CITY OF ALBUQUERQUE

**RE: 5179 Golondrina NW
Grading and Drainage Plan
Engineer's Stamp Date: 05/25/2026
Hydrology File: F11D005A
Case # HYDR-2026-00062**

Based upon the information provided in your submittal received 02/26/2026, the Grading and Drainage Plan **is not approved** for Grading Permit and Building Permit. The following comments need to be addressed for approval of the above referenced project.

GOLONDRINA NW

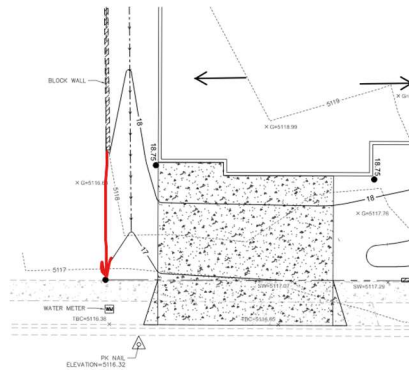
1. Please extend the wall all the way to the south property line or provide a barrier to contain the stormwater to the property for conveyance to the right-of-way.

ENGINEER'S SEAL	114 AMENDED TRINITY RANCH ADDITION 5179 GOLONDRINA NW GRADING AND DRAINAGE PLAN	DRAWN BY MM
DAVID SOULE P.E. #14522	Rio Grande Engineering ALBUQUERQUE, NM 87199 (505) 321-8099	DATE 2-24-2026
		SHEET # C1
		JOB #

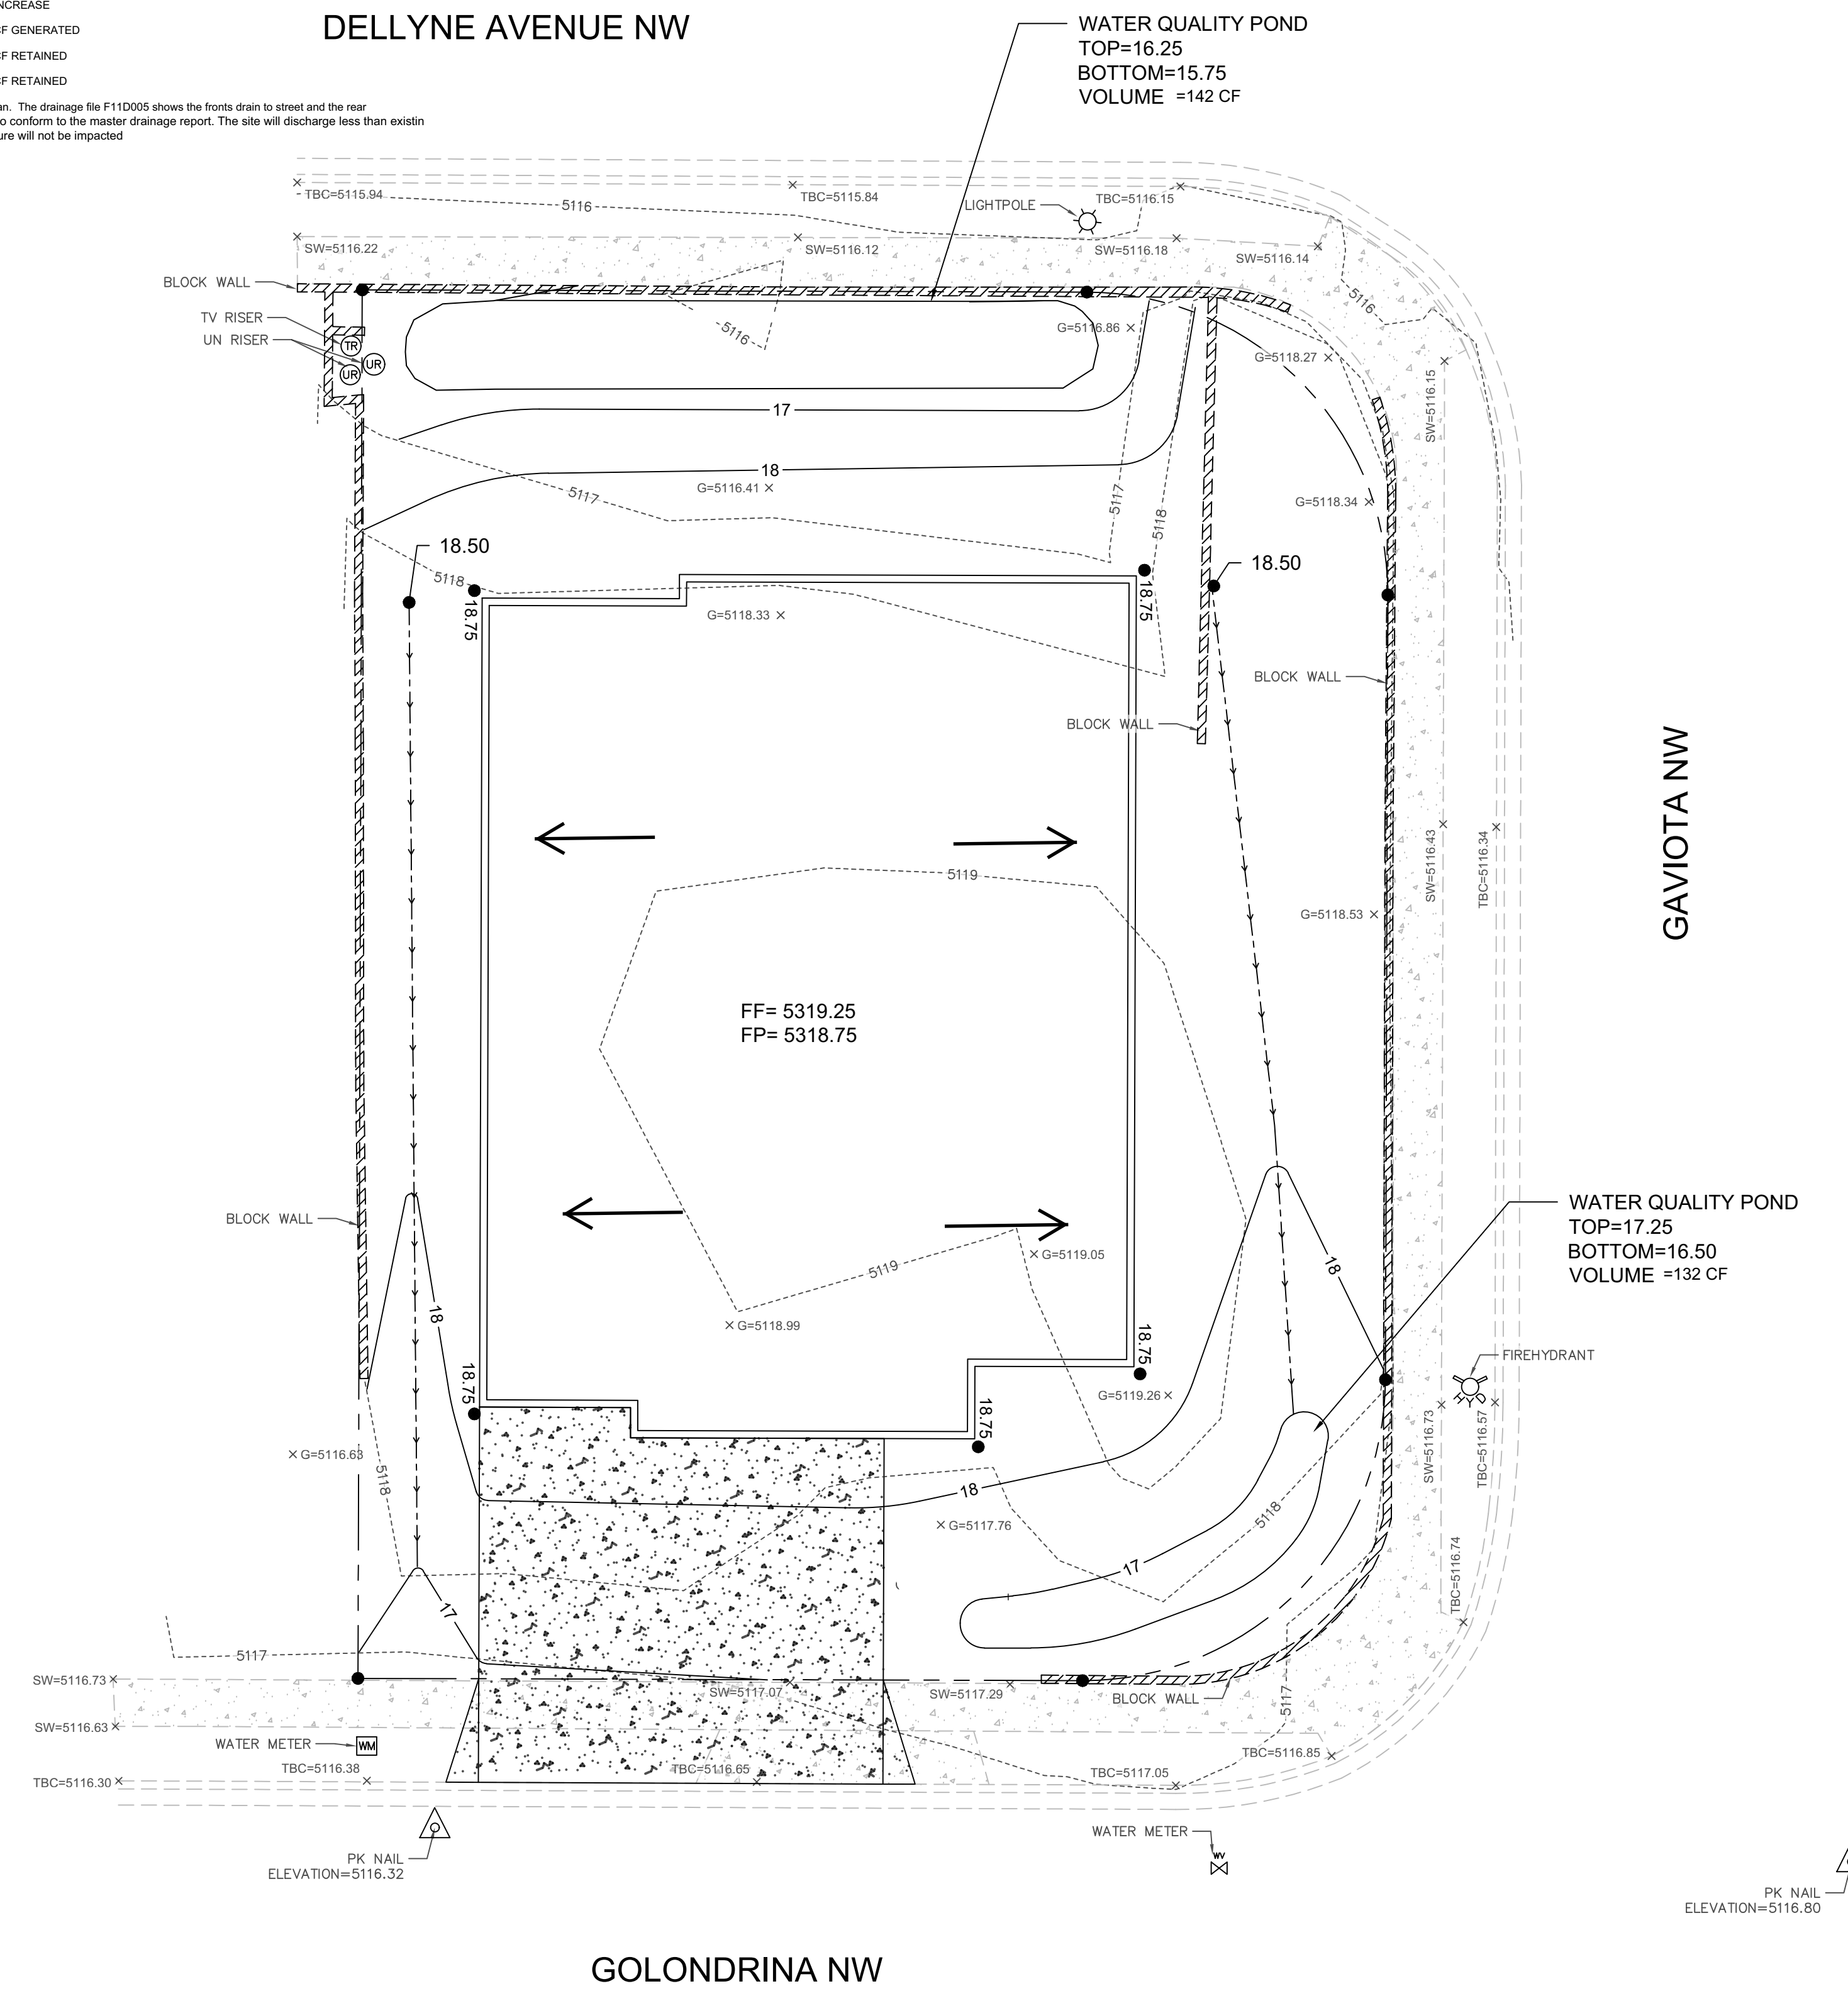
2. Include project benchmark and datum.
3. Remove note #5. A pad certification is not required for this site.
4. Add the floodplain note with effective date.
